AGENDA ITEM NO: 7.7

SUBJECT: Scott & Lindsay Armstrong  
Development Permit / 10595 Bell Road DATE: October 3, 2023

DEPARTMENT: Planning Department  
DP001740 PREPARED BY: Krista Desormeaux / mb

## STAFF REPORT ON DEVELOPMENT PERMIT DP001740

**7. DEVELOPMENT PERMIT AREA NO. 10 DESIGN GUIDELINE CHECKLIST:**

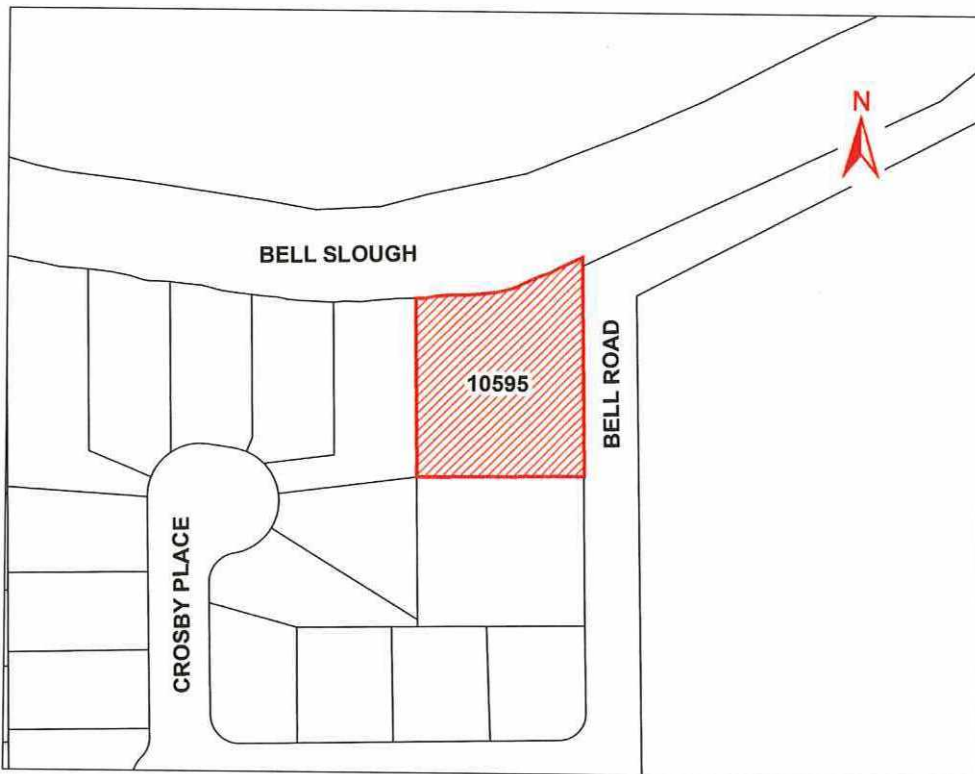
Use of frosting and/or clerestory windows on walls facing neighbouring properties	No	Recommend that windows on the rear elevation of the coach house be frosted to ensure privacy for the adjacent neighbour is retained, applicant has agreed to this. Windows along the east elevation are not frosted. This departure from the Design Guidelines is considered supportable in this instance as the non-frosted windows face an agricultural property with a residential dwelling over 200m away.
	Skylights used	N/A	No skylights are proposed
	Design reflects and incorporates natural terrain in areas with steep slopes.	N/A	Property not located within hillside.
	Balcony and/or deck is oriented towards principal dwelling and is less than 3.0m in height	No	The proposed deck is less than 3m in height but is oriented towards the front lot line. The deck faces a large field and does not impact privacy of surrounding neighbours.

Single garage doors or double garage doors with windows or other architectural elements are used	N/A	Two single garage doors are proposed and both have an awning above to break up the solid wall.
<b>2</b>	<b>Siting</b>		
	Coach house or garden suite is located behind or beside the principal dwelling	Yes	The coach house is located behind and beside the principal dwelling.
	Coach houses and garden suites accessed off of a lane include a recessed, covered landing or "stoop"	N/A	Coach house is not accessed off a rear lane
	Front door is oriented to the adjacent right-of-way, in the case of a corner lots with laneway access	N/A	As above.
<b>3</b>	<b>Access</b>		
	Shared driveway access or from laneway or flanking street	Yes	The coach house will have shared driveway access with the principal dwelling.
	Address signs provided	No	The plans submitted do not denote an address sign. As such, a condition of the Development Permit is that an additional address sign be placed at the street entrance in order to clearly identify the unit for visitors, deliveries and emergency responders
